HP PERMIT NUMBER: HP-0708-2025

PROPERTY ADDRESS: 1214 South Newport Avenue

HP PERMIT NUMBER: HP-0684-2025

PROPERTY ADDRESS: 1204 S Newport Ave

1204 S. NEWPORT AVE
PATIO PROJECT

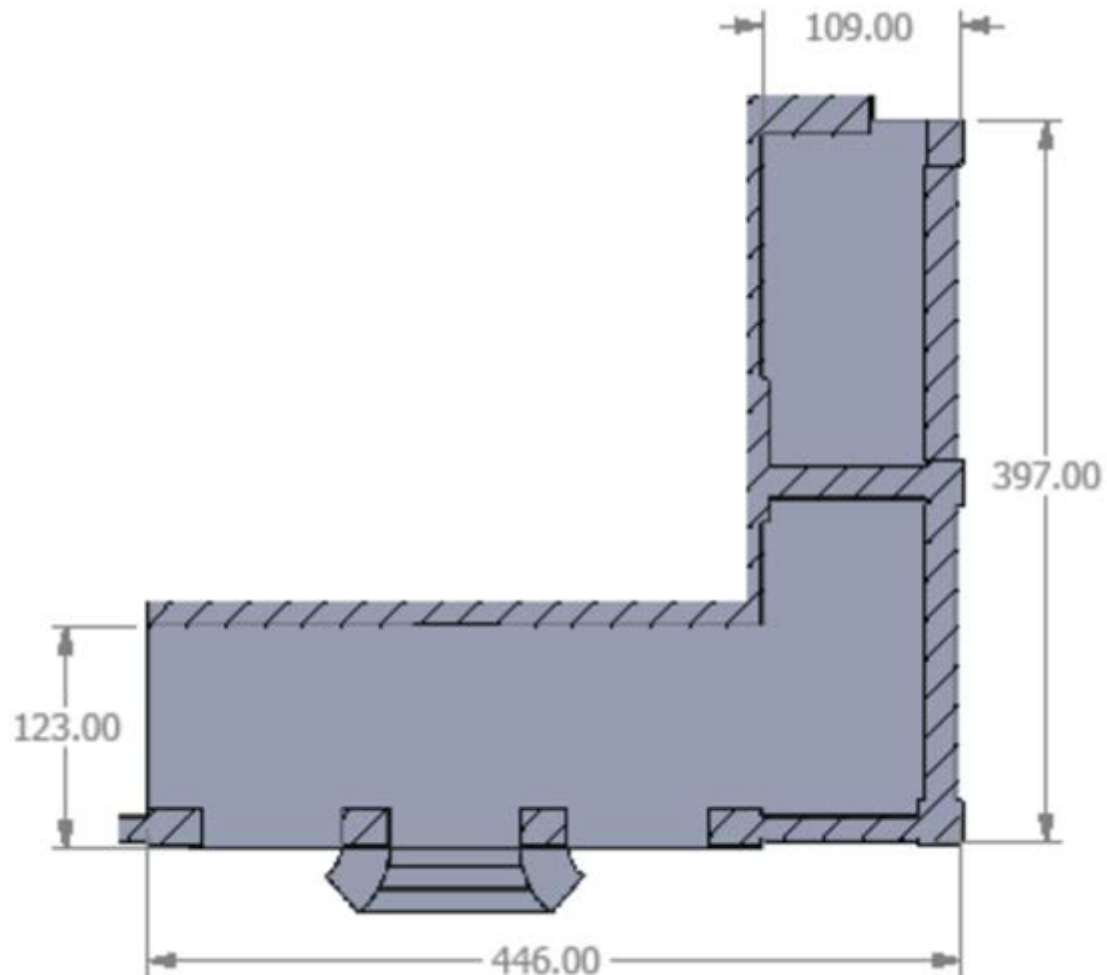
The applicants have since explored several porch columns and post options since the last commission meeting and the applicant would like to remove the existing wood columns and restore them to a shorter more historic square brick pillar style (with no posts) and top with the excavated caps from their yard that match existing caps located at other points along the porch and matching those proposed on the new stairs as discussed in the previous commission meeting.

Proposed Plan: Restore square brick columns on porch, rebuild steps and add brick detail and cap as shown.
